JOINT REGIONAL PLANNING PANEL (Sydney East Region)

JRPP No	2015SYE052
DA Number	DA-2014/203/A
Local Government Area	ROCKDALE
Proposed Development	Modifications comprising internal reconfiguration, changes to landscaping, increase in residential units from 185 to 213 and increase in carparking spaces from 250 to 259
Street Address	4-6 Princes Highway, Wolli Creek
Applicant/Owner	Dickson Rothschild
Number of Submissions	One (1)
Regional Development Criteria (Schedule 4A of the Act)	The proposal is a S96 Application to a development that has a capital investment value of more than \$20 million
List of All Relevant s79C(1)(a) Matters	<p>List all of the relevant environmental planning instruments s79C(1)(a)(i);</p> <ul style="list-style-type: none"> • SEPP – 55 – Remediation of Land • SEPP 65 – Design Quality of Residential Flat Development • Residential Flat Design Code • SEPP Infrastructure 2007 • Rockdale Local Environmental Plan 2011 <p>List any proposed instrument that is or has been the subject of public consultation under the Act and that has been notified to the consent authority: s79C(1)(a)(ii);</p> <ul style="list-style-type: none"> • Draft SEPP 65 – Design Quality of Residen

Figure 2 - Approved protrusions in yellow

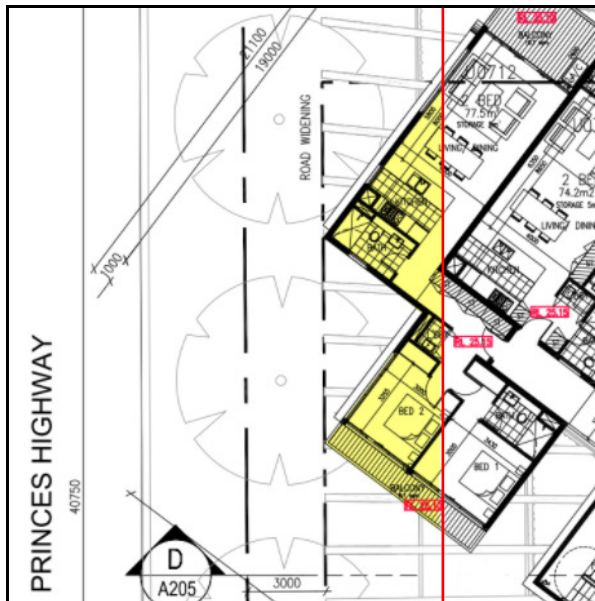
4. Highway Interface – Upper level setback

Part 7.1.8 of DCP 2011 requires a setback 5m to the building alignment above level 5 of the development from the new property boundary. The development was approved with a minor variation to this setback, being 2 triangular forms to the westernmost tower, which encroached into the setback area and had a nil setback to the new property boundary. These triangular portions included part of the units and common corridors within the development. This portion of the building is oriented towards Cahill Park and as such resulting in the triangular components of non compliance.

Figure 8 - Proposed VPA Offer diagram

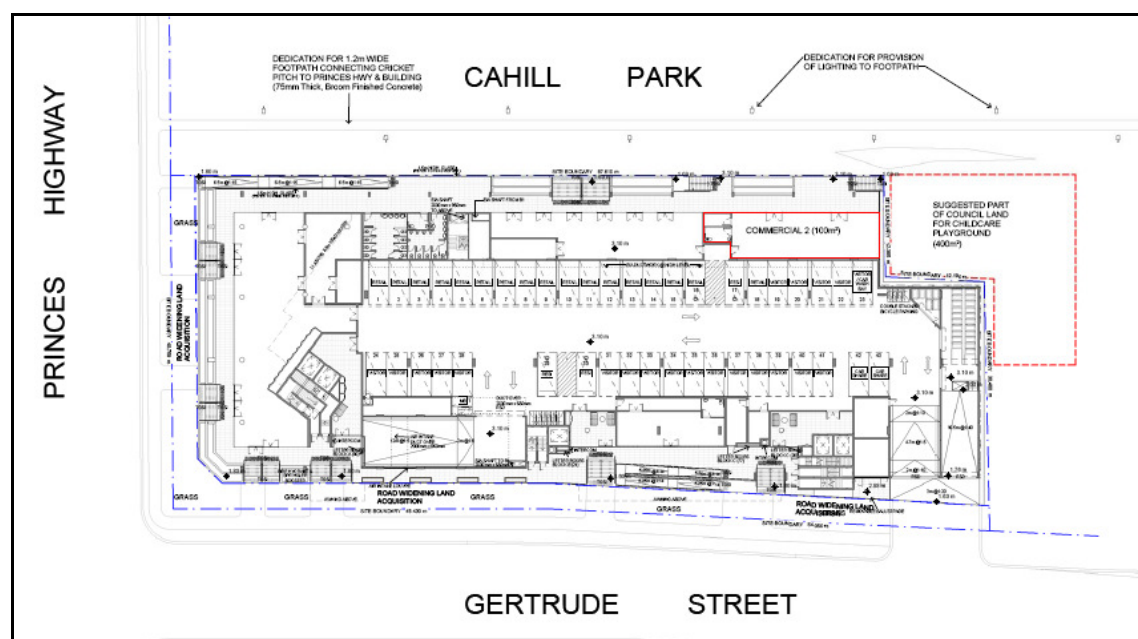
- a) *Design and construct at its own cost the landscaping and lighting works generally in accordance with the attached drawings and images.*

Figure 13 - Terraced Planters as proposed

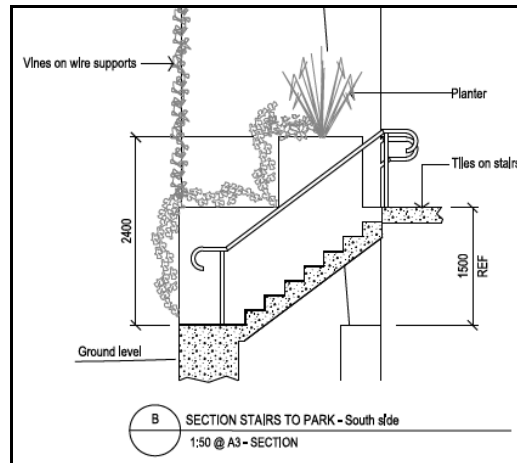
The proposal seeks to raise the basement level by 0.55m, resulting in the ground level of the development increasing from 2.85RL (minimum habitable flood level as approved - 1.35m above natural ground level) to 3.10RL (1.6m above natural ground level).

The proposal as modified further seeks to delete the ground level periphery stairs to the northern, southern and western sides of the development. These are proposed to be replaced with narrower stairways for pedestrian entry & raised pedestrian circulation areas & masonry rendered planters, ranging in height from 1.5m – 2.4m in height above footpath level.

Despite the proposed treatment of terraced planters with shrubs, including trailing plants, & the submission of indicative maintenance details, concern is raised in regards to the height and appearance of the proposed terraced planters & masonry walls at site boundaries.

Figure 14 - Eastern facade planter boxes as Approved

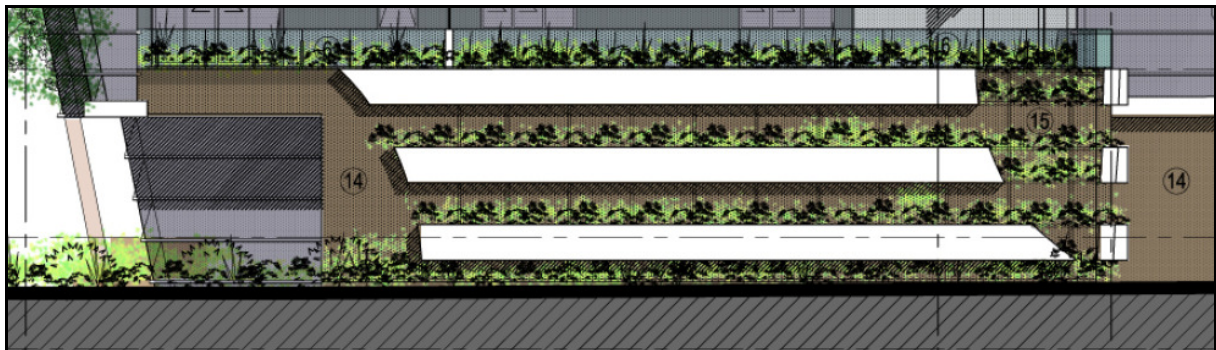
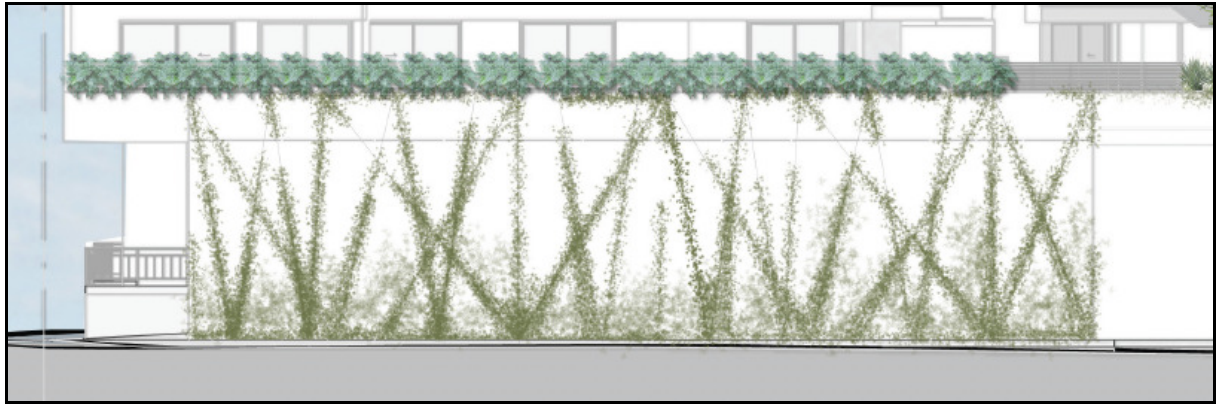
In addition to the above, as originally approved, a component of the eastern & north eastern facades of the development at ground level adjoining the loading dock were approved with a row of three horizontal irrigated planter boxes, finished with metal cladding. These were simple to maintain, manage and comprised in built irrigation and drainage.

Originally approved planter boxes obscured the blank masonry loading dock wall, providing human scale, visual interest and building modulation when viewed from Cahill Park.

The proposal as modified has deleted planters & seeks to provide a vertical stainless steel wire vine support system in their place. Given the 4.5m height of the loading dock wall and its substantial length, 19.5m (eastern side) & 12.2m (northern side), reliance on ephemeral planting to mask the appearance of expansive blank walls at site boundaries is not appropriate, as the body corporate may or may not maintain these areas into the future.

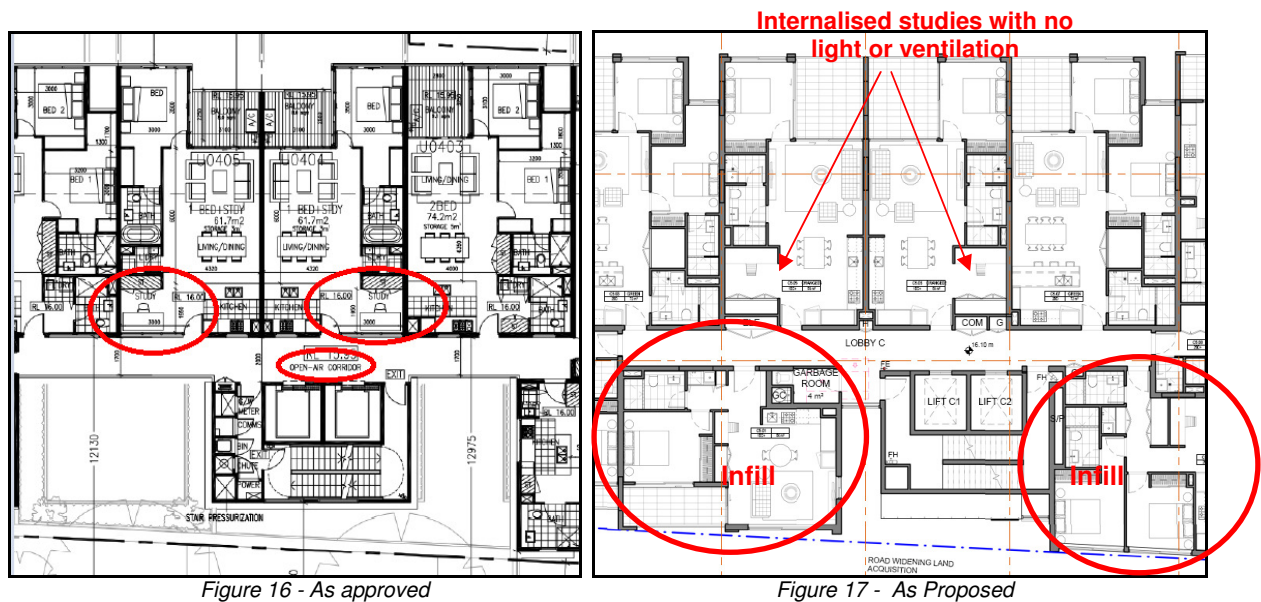
- Deletion of originally approved wrap around stairways which provided a stepped transition up to the ground level of the building.
- Provision of 1.6m high solid masonry walls located upon the Gertrude Street boundary with balustrading and planter boxes above. Resulting in a total height of up to 2.4m above footpath level.

- Introduction of narrow stairways & raised walls / planters results in reduced line of sight and potential for safety issues. The height & design of solid raised walls / planters is inconsistent with Crime Prevention through Environmental Design Principles.

- The raised walls / planters result in a non active street frontage with poor integration and delineation of public / private interface.
- The scale of the public / private interface is confronting, particularly given the proposed hard landscape edging at the boundary.

- Potential for ephemeral planting at the eastern facade to fail.
- The unnecessary raising of the basement level and consequently ground level of the development above and beyond the minimum habitable flood level.

Given the above, the proposal as amended provides a poor relationship to the street & public domain.

Figure 18 - Excerpt from original Wind Report louvers required to balconies levels 2-7

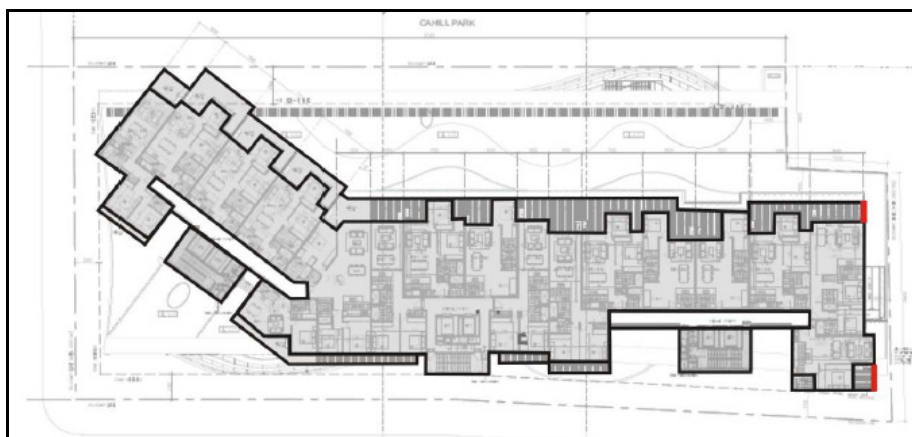
A wind assessment report submitted with the original application required a number of design features to be provided on site in order to protect the development & future occupants from adverse wind gusts. These included the provision of full height impermeable / louvered screens to corner south eastern balconies of the development as follows:

- *Provision of full height impermeable or louvered screens along the SE perimeter of the SE private corner balconies on the east tower on levels 2 – 7.*

The proposal as modified has altered the building footprint, reconfigured internal floor layouts and deleted south eastern balconies.

Given the above noted changes to the design of the development and deletion of balconies at the SE corner, it is considered that a revised wind report should have accompanied the application, as the recommendations of the original report are now inconsistent with the design of the proposal as amended.

Figure 19 - Excerpt from original Wind Report louvers required to balconies levels 2 - 13

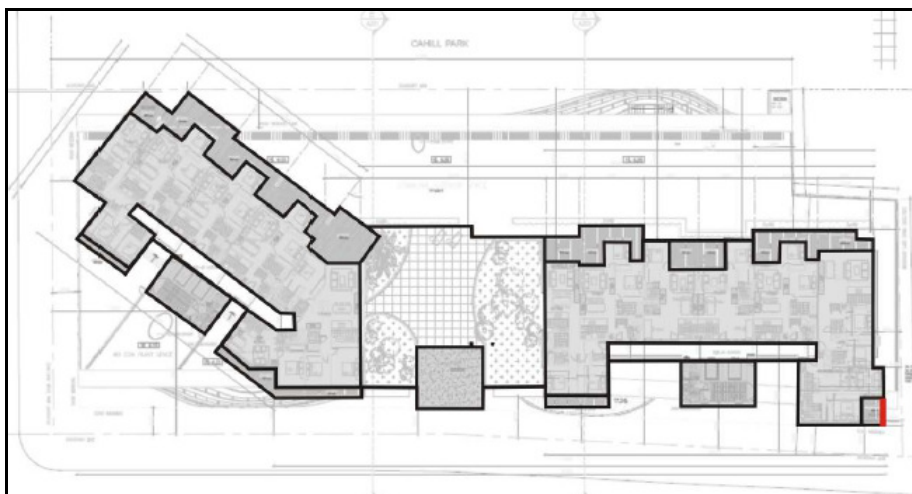
- *Provision of full height impermeable or louvered screens along the SE perimeter of the SW private corner balconies on the east tower on levels 2 – 13.*
